SUBJECT: Forwards addl info for environ review of Pond Hill low flow augmentation reservoir, in response to 790928 request. Eight oversized drawings encl. Also forwards "Monitoring Study of Community Impact" & update.

SUSQUEHANNA STEAM ELECTRIC STATION  
POND HILL RESERVOIR INFORMATION  
ER 100450 PLA-411 FILE 841-2, 991-2

DOCKET NOS. 50-387  
AND 50-388

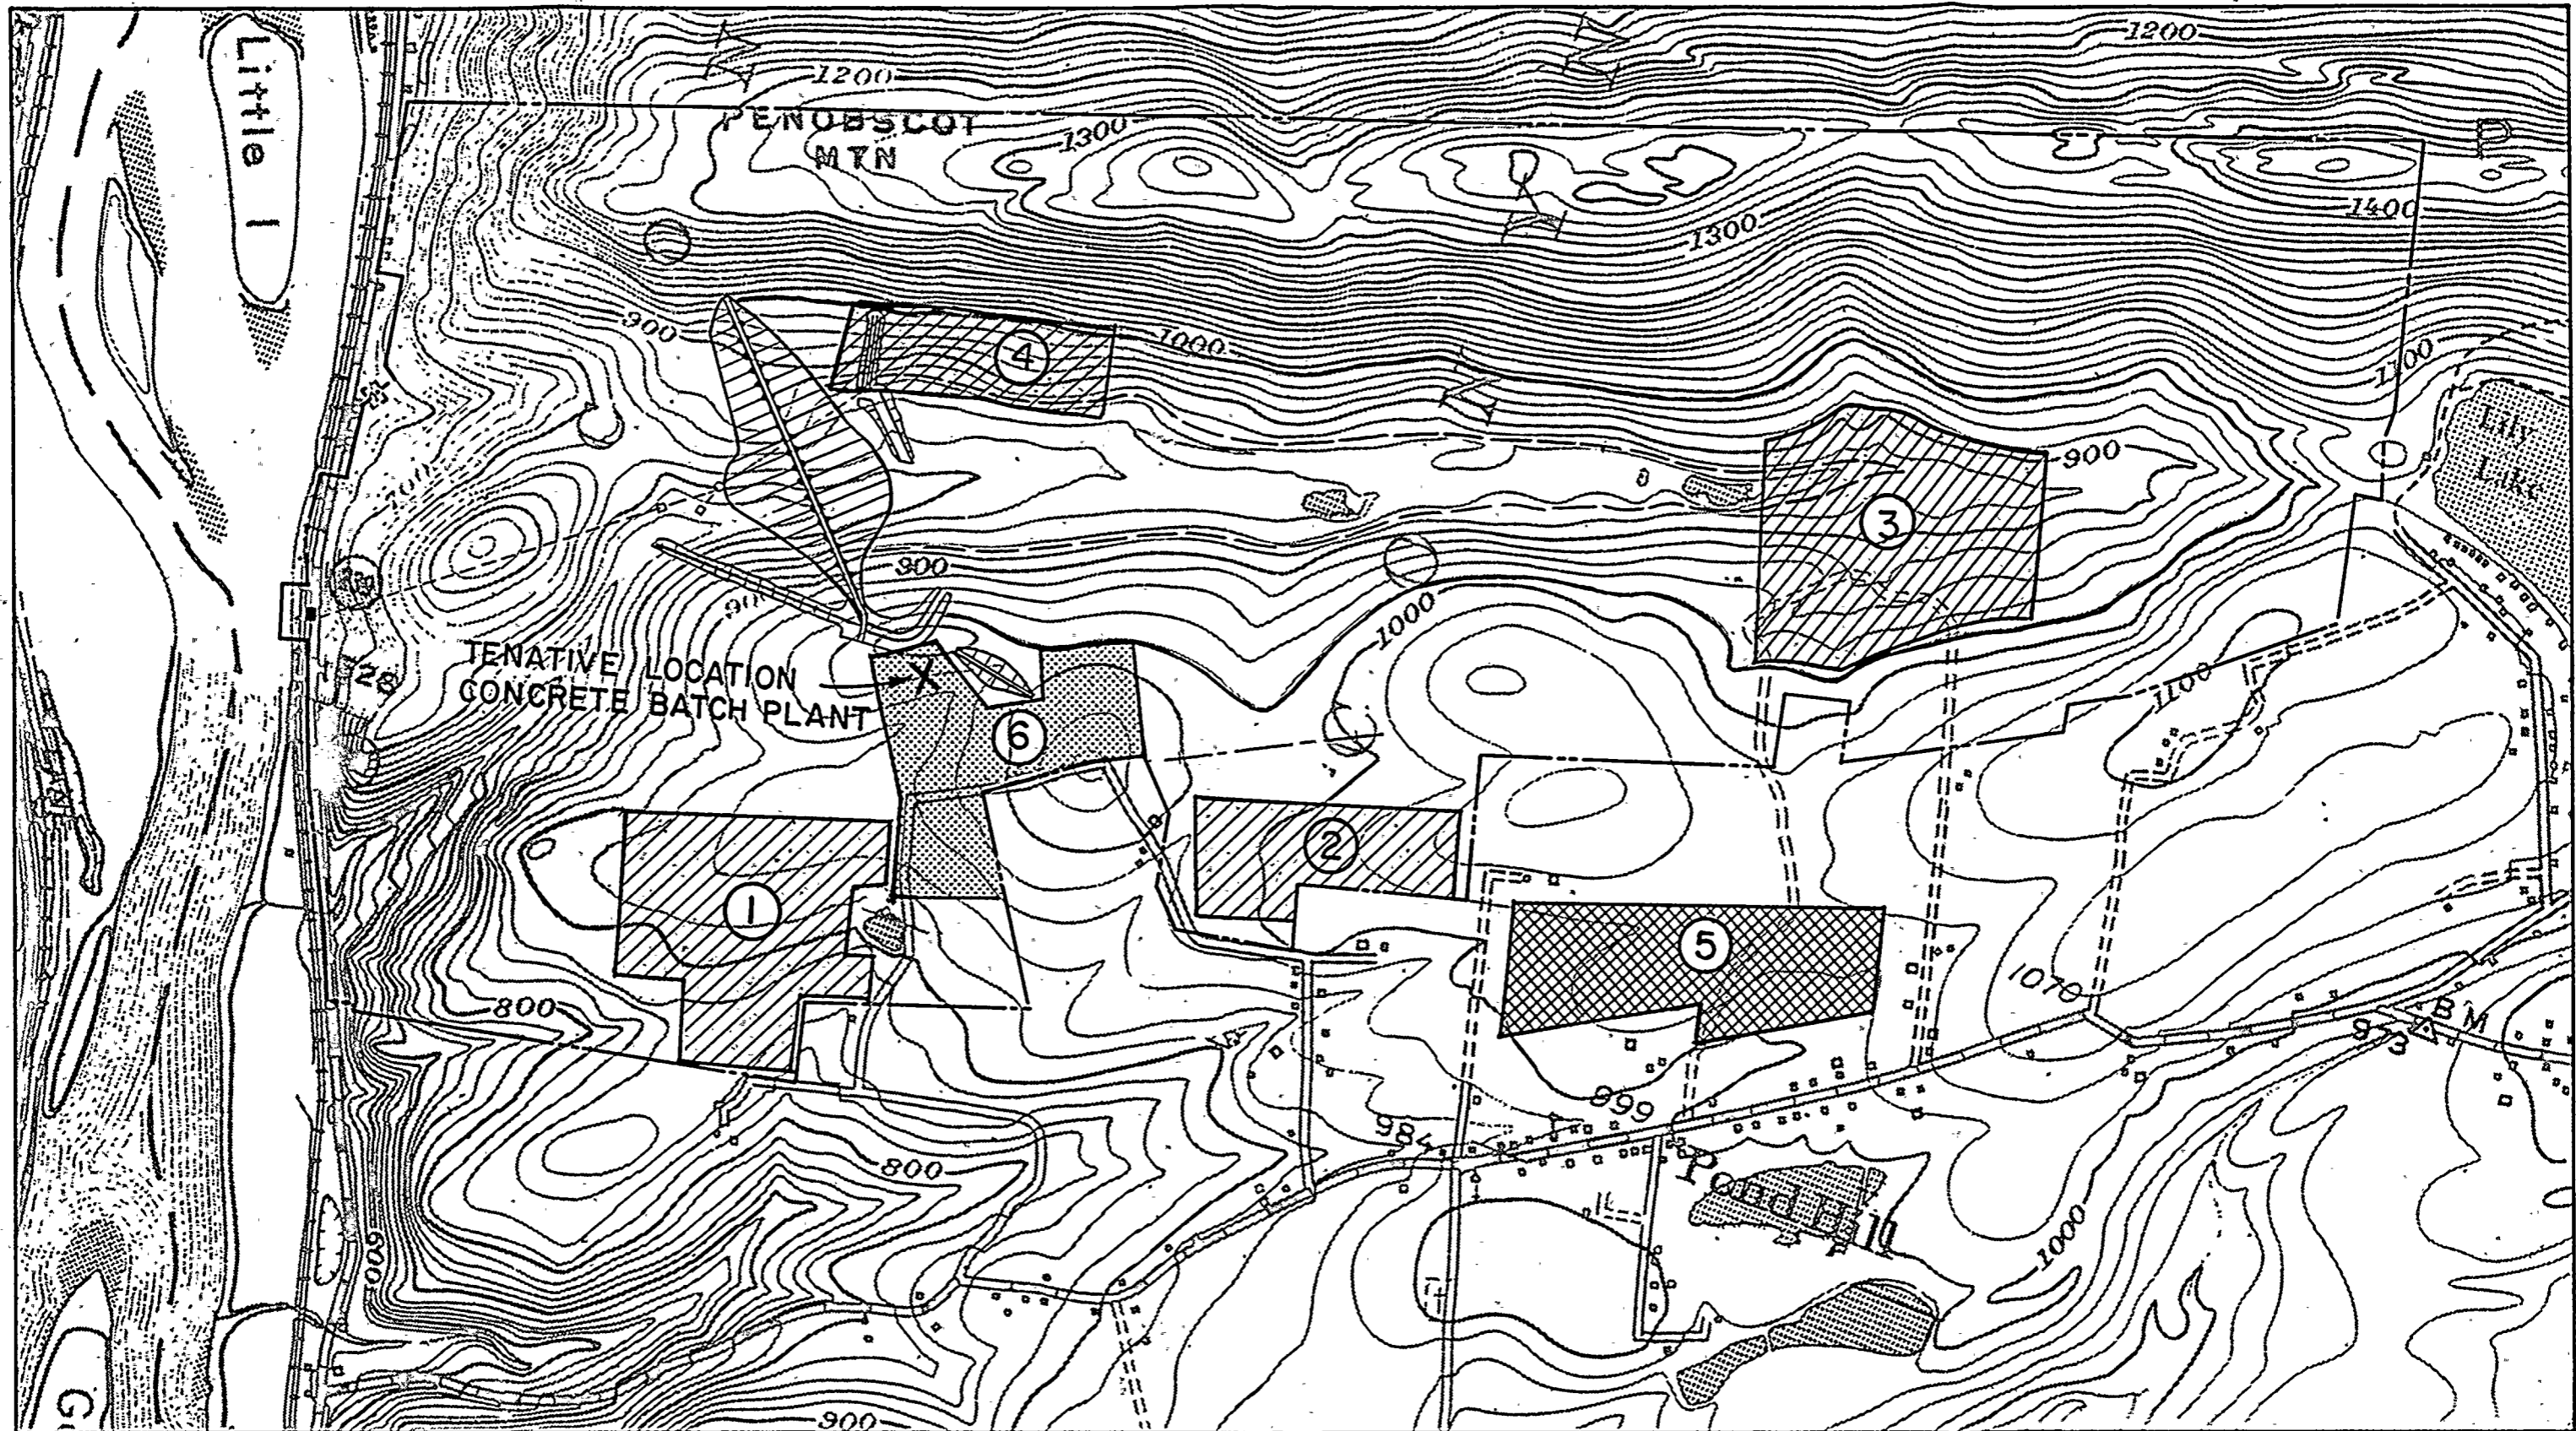
Plate 19 (attached) shows the preliminary location of the Contractor's staging area which will contain parking and laydown areas, batch plant, office trailers and other required facilities. The location of the staging area and facilities within the staging area will be dependent on the Contractor's work plan and requirements. As this area is adjacent to the existing Township road, no additional access roads may be required. The Contractor will be responsible for the location of any haul roads and/or additional access roads he may require.

At this point, it is assumed that a concrete batchplant will be needed and a location is indicated on Plate 19. The need for and location of a batch plant will be based on the construction Contractor's recommendations. The area which will be required by construction and yard requirements will depend on the contractors proposed plan of operation.

Based on our current knowledge of the soils in the area, we anticipate that borrow for the dam will come from the areas shown in Plate 19. The approximate acreages for the various borrow areas are shown in the response to question 5. We expect that borrow depths will be between about 5 and 20 feet or more, depending on the depth of material present. Borrow area 4 is anticipated to be the source of rock materials. Borrow area 3 is anticipated to be the first source of core material with areas 1 and 2 secondary sources used only if needed. Area 5 has been identified as a possible source of suitable core material, but is not anticipated to be necessary. Filter material will either be purchased from local quarries (about 5 miles south of the site) or processed on the site.
